Re: Permit Application P38562 – Airlie, 452 St Kilda Road, Melbourne (H0722)

I refer to a request for further information (RFI) received from Heritage Victoria, dated 25 January 2024, in relation to permit application P38562 for works to Airlie, 452 St Kilda Road. The following information was requested in the RFI:

Basement entrance under the rear (servants) staircase

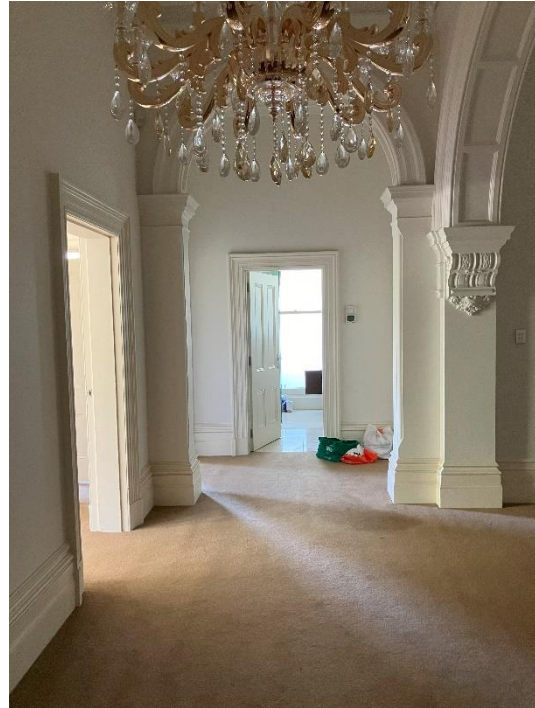
- A copy of the 2005 Conservation Management Plan prepared by Lovell Chen.
- Renders showing the proposed new acoustic wall (without vegetation), conservatory and carport.
- Outline of the options considered for the location of the lift and associated impacts.
- Outline of impacts associated with the proposed basement entrance under the rear (servants) staircase
- Existing conditions photographs of the location of the following proposed works:
 - basement entrance under the rear (servants) staircase
 - areas impacted by the lift
 - the location of the glazed doors with side panels at first floor
 - ensuite on the first floor (front room).
- Proposed Landscape Plans

1. The existing service enclosure below Stair 3 will be removed. The lower section of this appears to be non-original, as detailed in the attached photographs. The upper section is heavily altered and is proposed to be removed.

The proposal will retain the existing service stairs and allow for the introduction of new stairs below to the basement level. The stair enclosure will be removed, but this appears to be heavily altered or non-original fabric and the existing details of the stairs, including the balustrade, will otherwise be retained.
